SKEP III Home Office Support Site Visit Report

Consultant	Wahib Medanat Consultant Engineer	Rep No.	22-15112021
Contractor	Dijlah Establishment Constr. Contracting	Tender No.	(11/2019/USAID/SKEP/3/S) Schools for a Knowledge Economy Project (SKEP) - Phase (3) Package (1, 2)
Site Name	Thahr Al Sarow Basic School for Boys- Jerash	Day/ Date	Mon. 15/11/2021
Duration of Project	450 Calendar Days	Total Project Budget	8,314,983.735 JD

(Figure: 05 & 06)

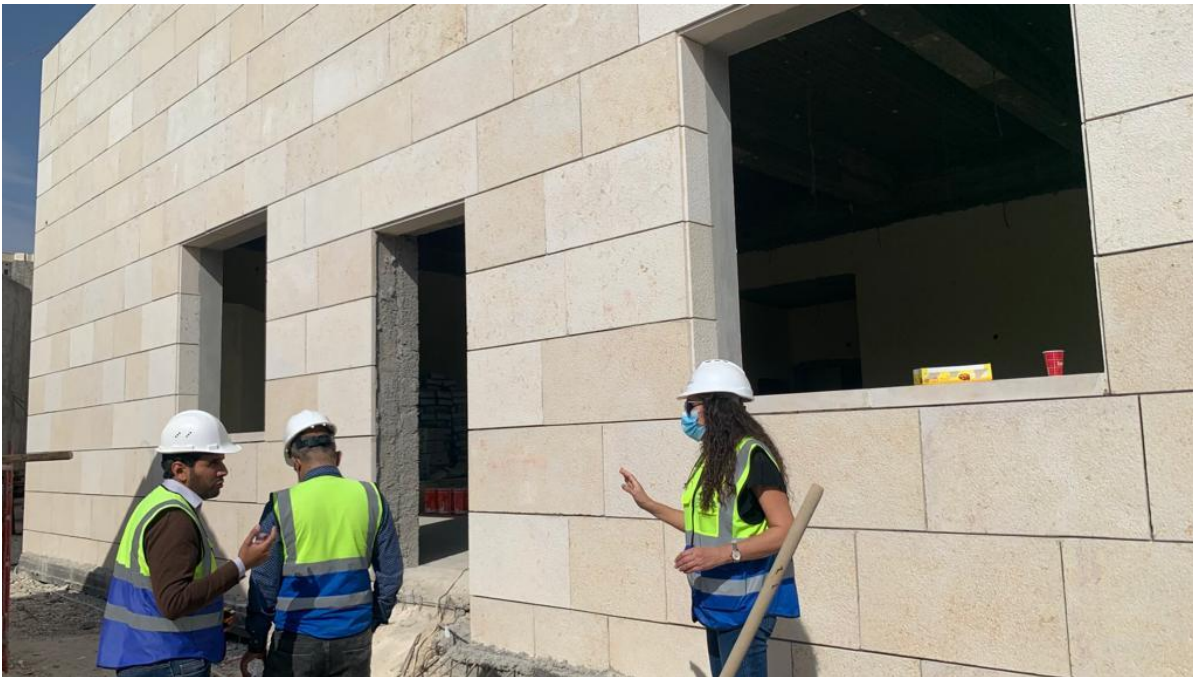
Visual inspection has been conducted on the delivered quantities of floor tiles and Musaman stone
